Living Streets Edinburgh Group

Audit of 'Spaces for People' provision: A702 Tollcross to Morningside Station

Location 27W (Morningside Road west):

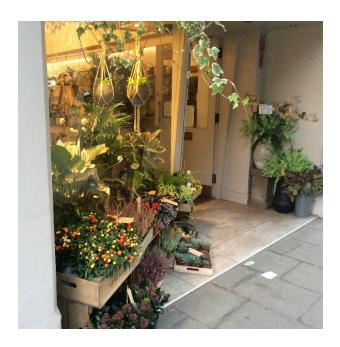
The pavement proper here is only 2.6m wide, and due to the depth of goods on display here, the Clear Walking Zone is only 1.2m in places (ie significantly less than the SDG 'absolute minimum' of 1.5m). Therefore the additional SfP space is welcome, albeit that the total width available for pedestrians is split into two levels rather than being continuous.

Section 129(9) of the Road Scotland Act 1984 forbids the placement of goods for sale on the public sections of the street. If alerted to such a problem, the Council can issue a statutory notice to the offending business and action then taken if they fail to comply.
